HISTORIC AND DESIGN REVIEW COMMISSION

November 02, 2022

HDRC CASE NO: 2022-399
ADDRESS: 363 NORTH DR
LEGAL DESCRIPTION: NCB 7026 BLK 5 LOT 16, E11 FT OF 18
ZONING: R-6, H
CITY COUNCIL DIST.: 7
DISTRICT: Monticello Park Historic District
APPLICANT: Thomas Gandy/GANDY THOMAS R
OWNER: Thomas Gandy/GANDY THOMAS R
TYPE OF WORK: Exterior modifications, fenestration modifications
APPLICATION RECEIVED: July 24, 2022
60-DAY REVIEW: Not applicable due to City Council Emergency Orders
CASE MANAGER: Edward Hall

RENOVATED FLOOR PLAN AND ELEVATIONS

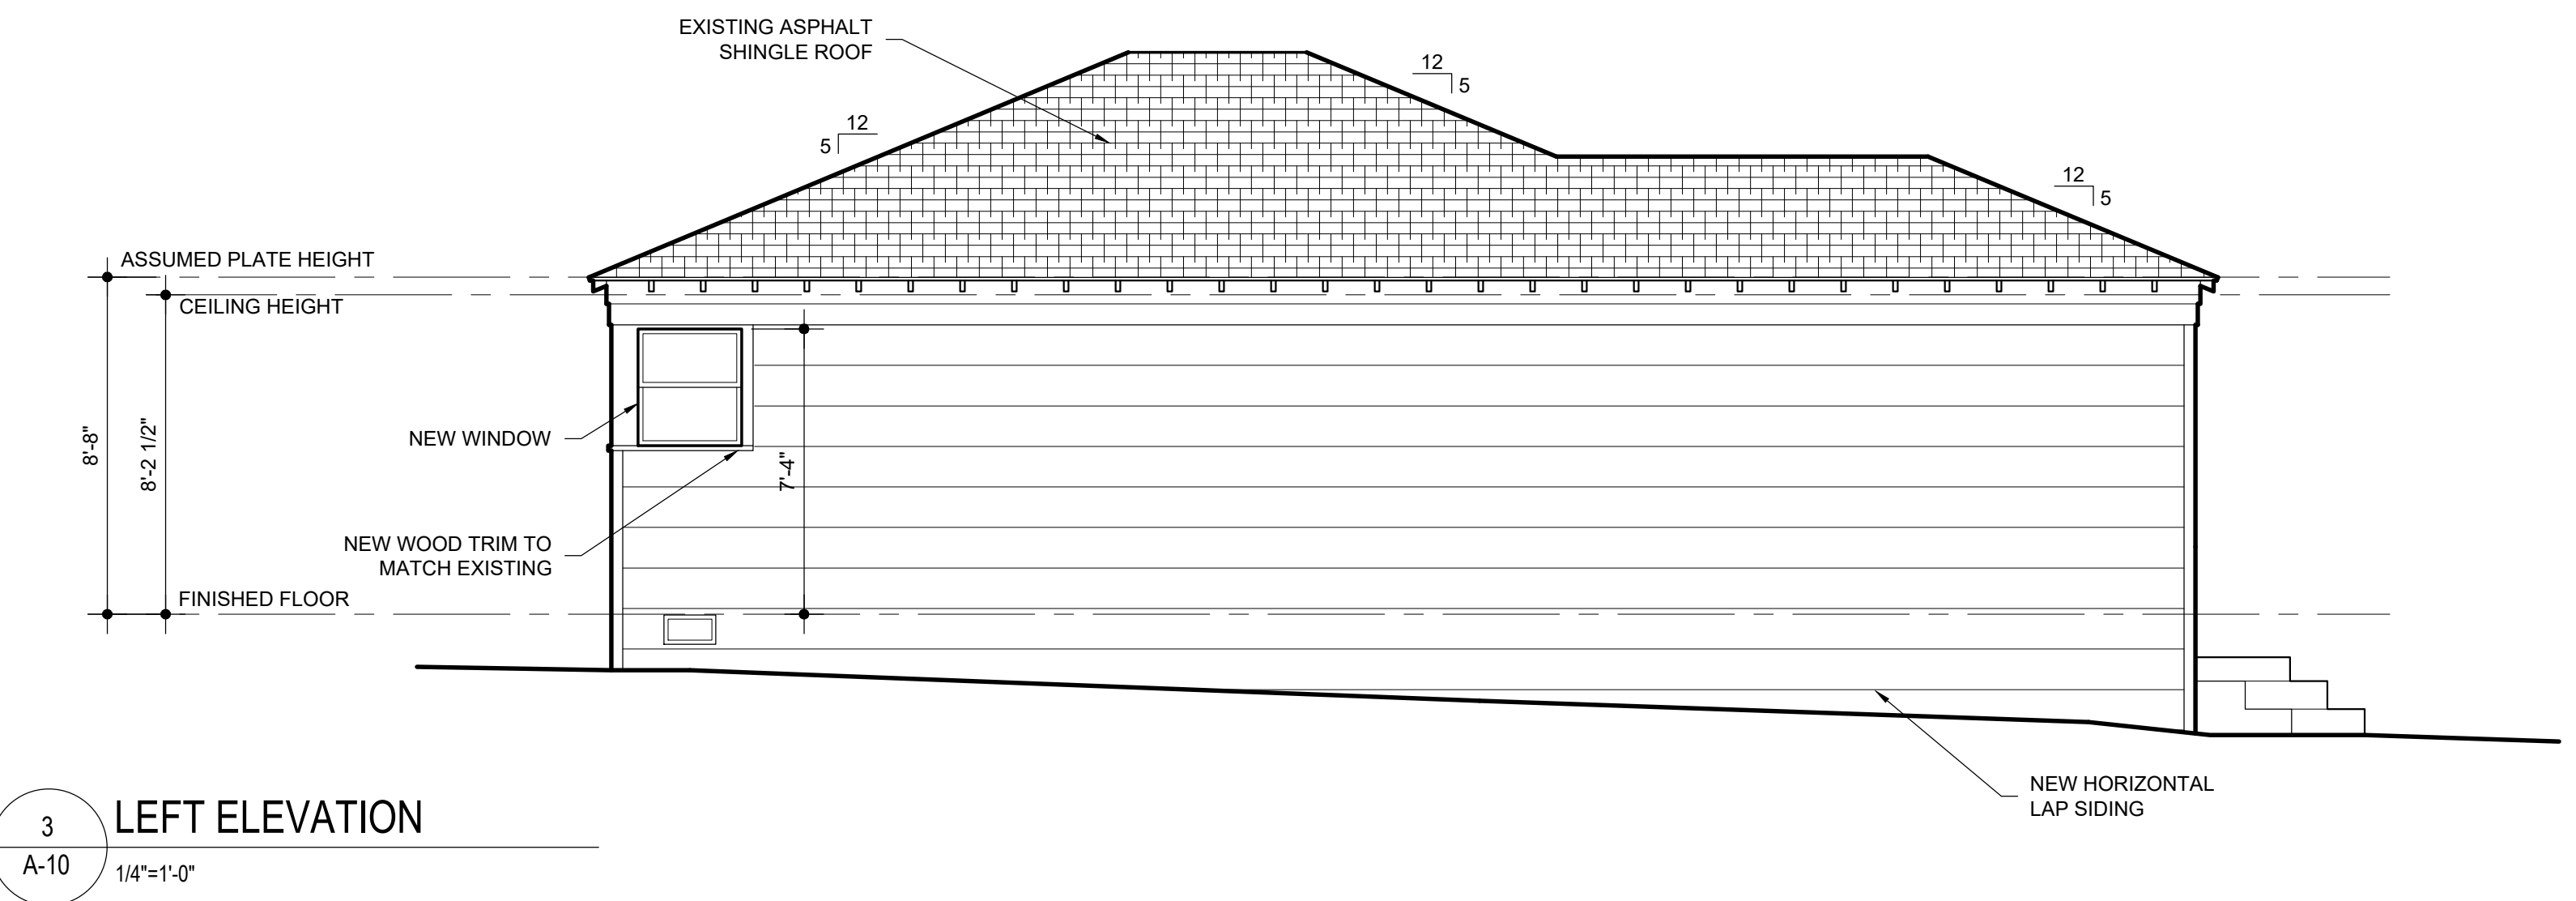
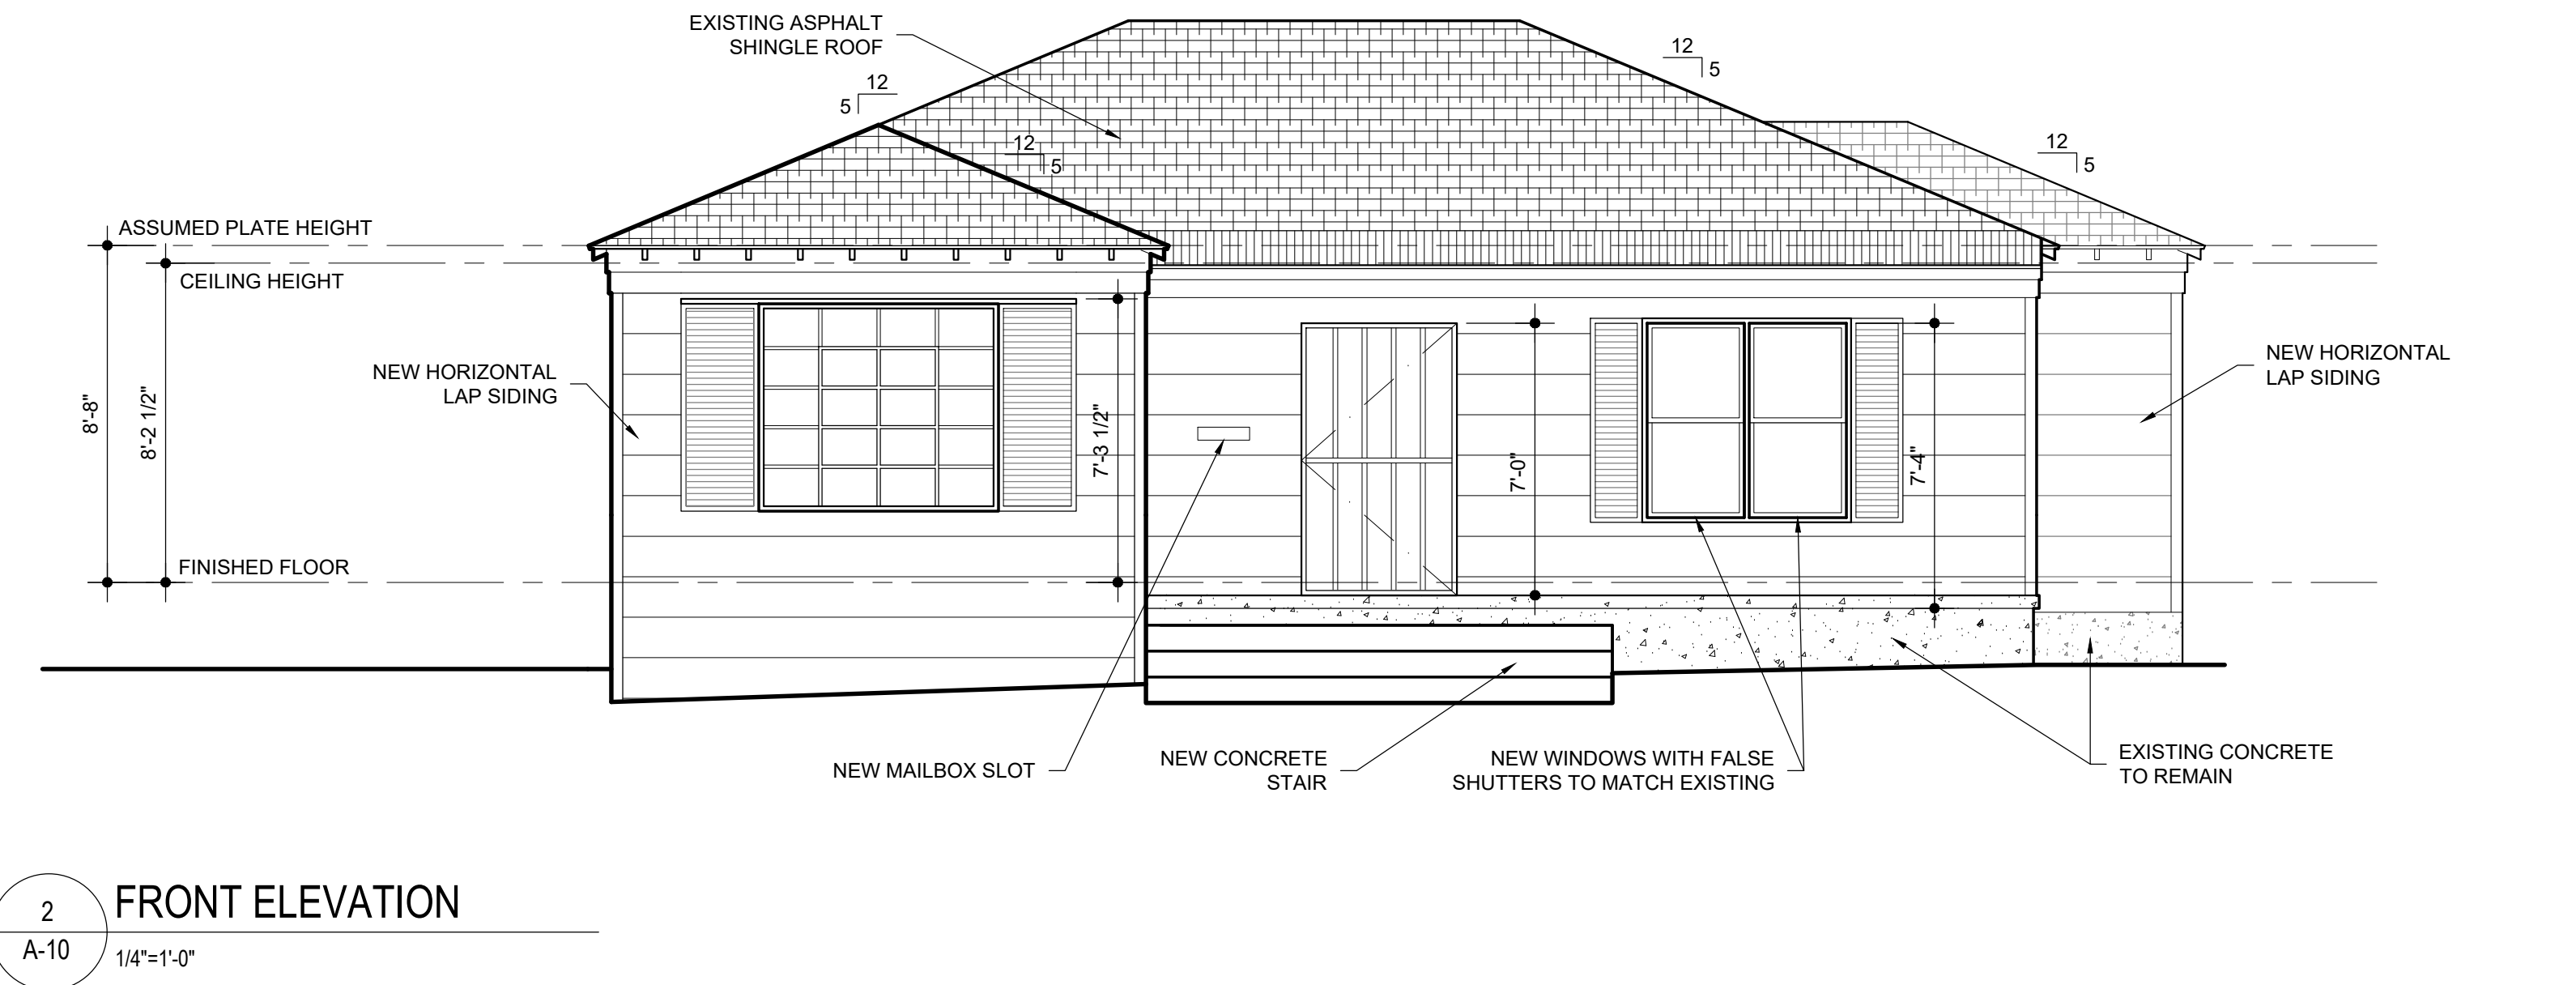
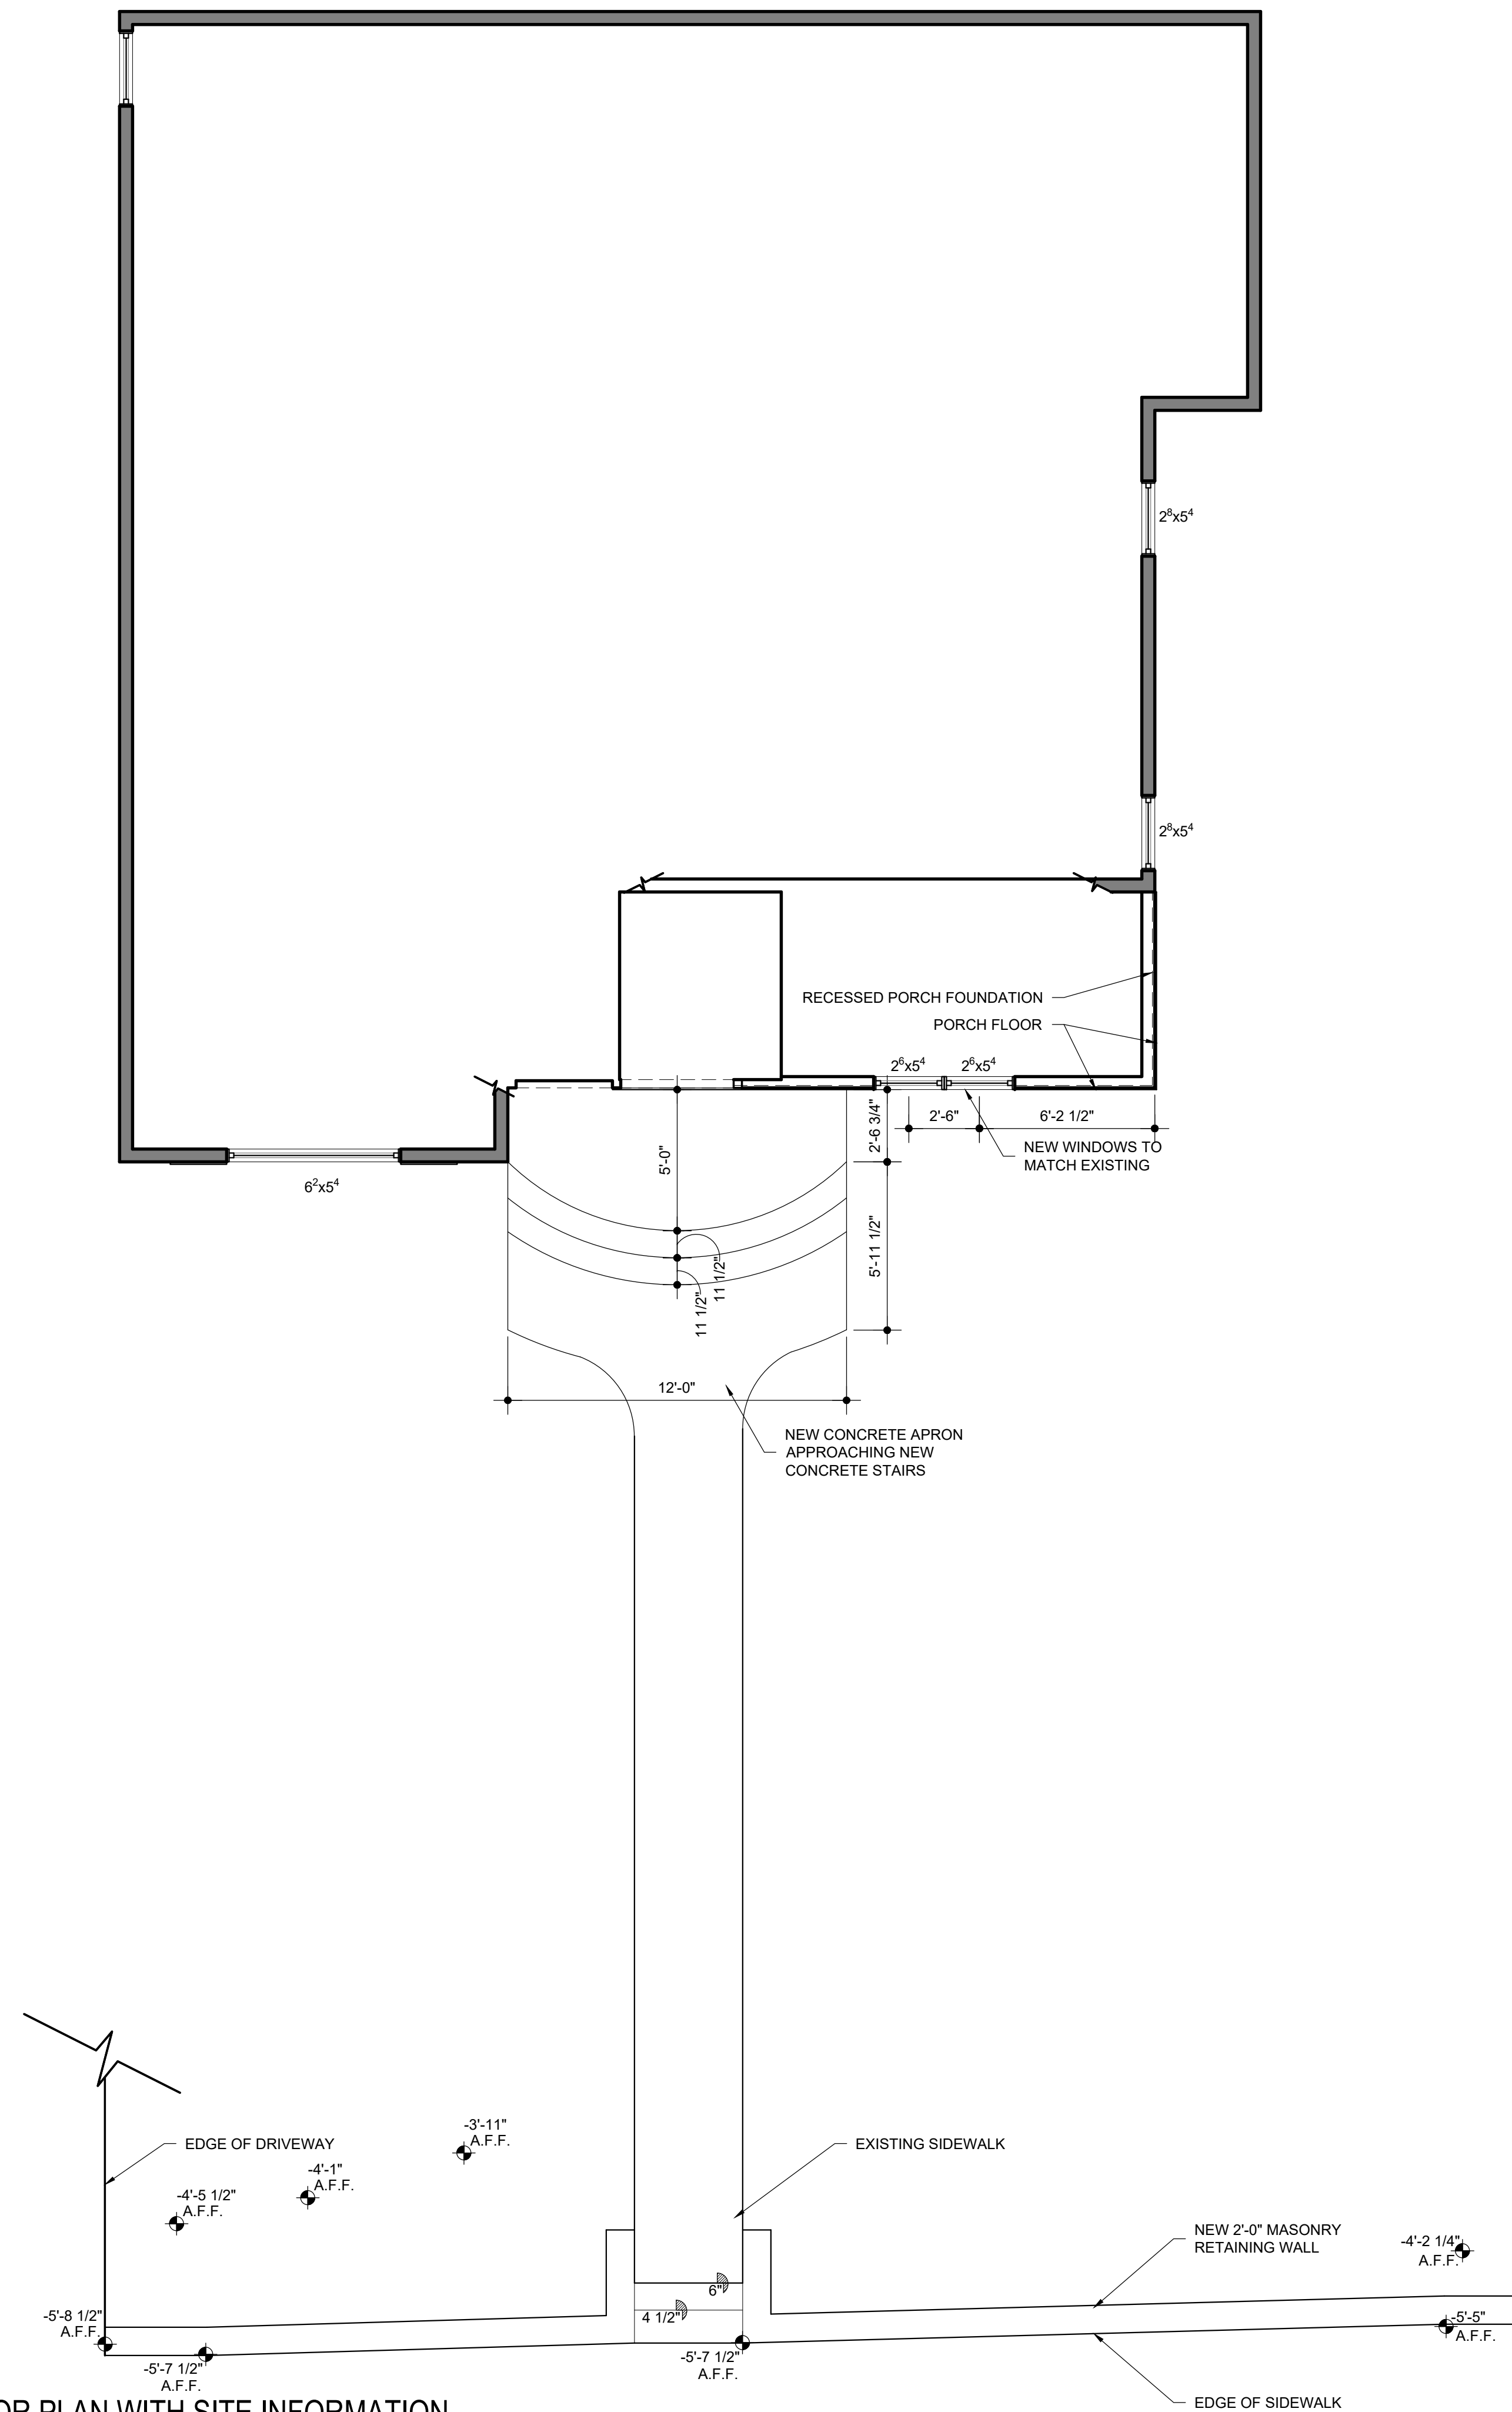
- f. EXTERIOR MODIFICATIONS (Front Façade) – The applicant has proposed to perform modifications to the front façade to include the installation of two, one over one windows on the front façade. This wall plane is not original and is the front of a previously enclosed front porch. The Guidelines for Exterior Maintenance and Alterations 7.A and B. note that front porches should not be enclosed. When porches are enclosed, the Guidelines note that they should function and visible read as a porch. Per photos, the front porch has been enclosed with screening elements since 2007, at least. Staff finds that either windows should be added across the entirety of the enclosed porch to read as an open element with visible porch columns, or that the structure should be returned to its previous condition.

- g. EXTERIOR MODIFICATIONS (Side Façade) – The applicant has proposed to perform modifications to the side (west) façade to include the removal of an existing door opening, and the removal of an existing concrete stoop and steps. Per the Guidelines for Exterior Maintenance and Alterations 6.A.i., exiting window and door openings are to be preserved. The proposal to remove the existing, side door is inconsistent with the Guidelines.

- h. FRONT PORCH STEPS – The applicant has proposed to install new, rounded concrete porch steps as well as a concrete apron to the proposed porch steps. The existing steps are clad in brick, but feature a minimal design and a width that is slightly wider than that of a pedestrian door opening. There is no historic precedent of an alternative porch design on site or within the district. Staff finds that the existing porch steps form should be maintained. In-kind replacement, with concrete would be appropriate, with no change to profile.

2. Staff does not recommend approval of item #2, modifications to the front façade, as noted in finding f. Staff recommends that either windows be added across the entirety of the enclosed porch to read as an open element with visible porch columns or that the structure be returned to its previous condition.

3. Staff does not recommend approval of item #3, modifications to the side (west) façade to include the removal of an existing door opening, and the removal of an existing concrete stoop and steps, as noted in finding g. Staff recommends that the door opening, concrete stoop and stairs be preserved.

4. Staff does not recommend approval of item #4, the installation of new, rounded concrete porch steps and a concrete apron as noted in finding h. In-kind replacement, with concrete would be appropriate, with no change to profile.
